CITY OF VICTORIA | Sustainable Planning & Community Development

# Development Permit with Variances Application

902 Foul Bay Road

COMMITTEE OF THE WHOLE | May 23, 2024

# Revised Site

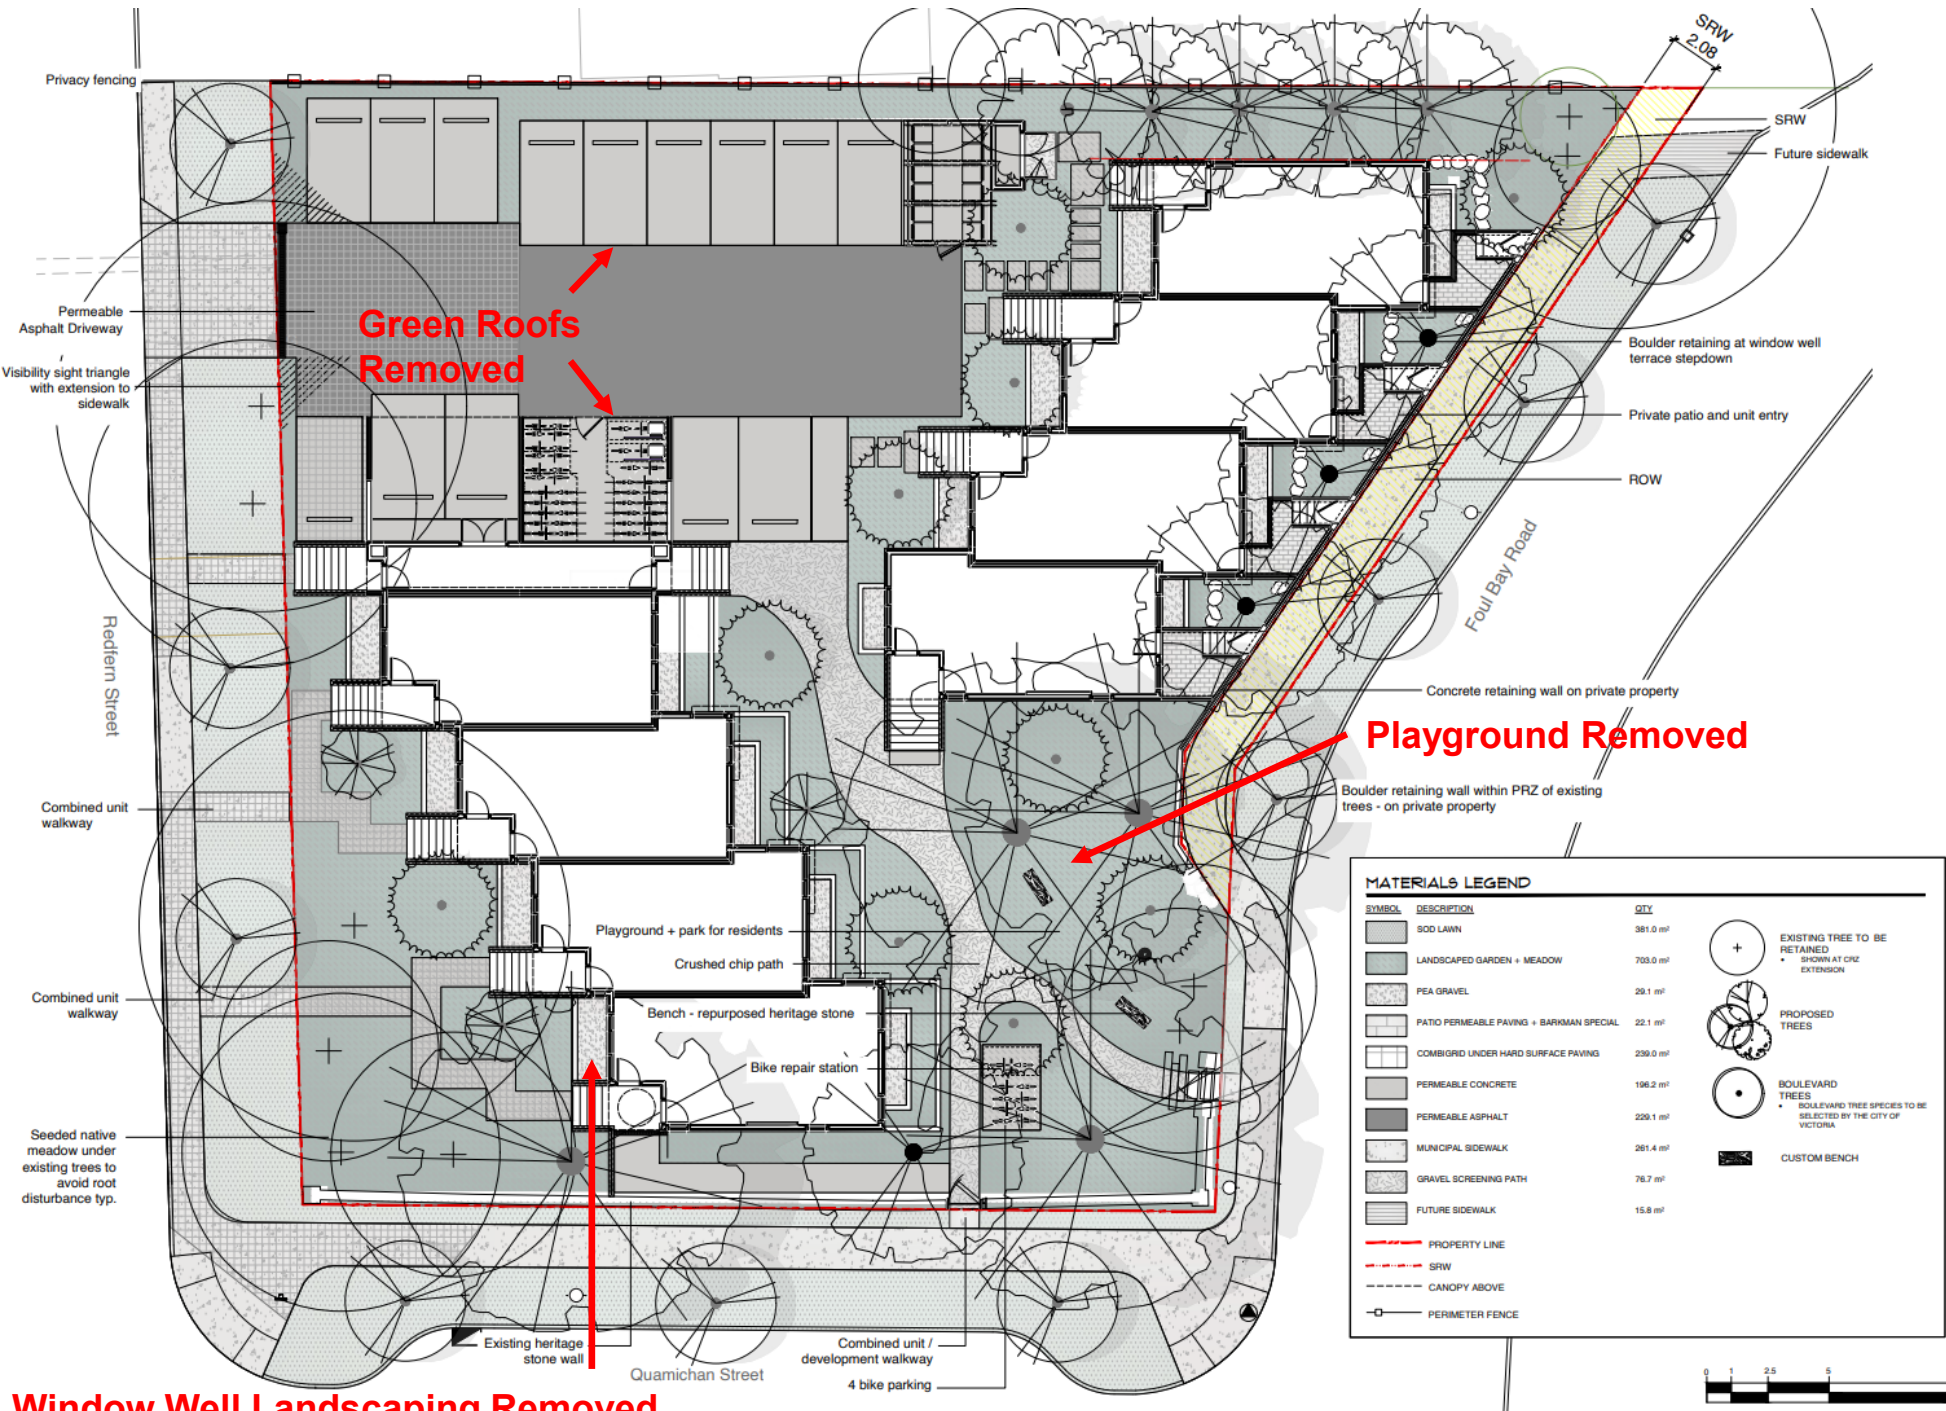
Mostly surface parking-  
green roofs removed over  
11 spaces

Playground and two  
benches removed

Landscaped area reduced  
(window wells, green roof  
area)

New variance to 1m  
landscaped buffer

Material changes (retaining  
walls, amenity walkway)

*\*Removed affordable  
ownership units (approved  
in 2023)*
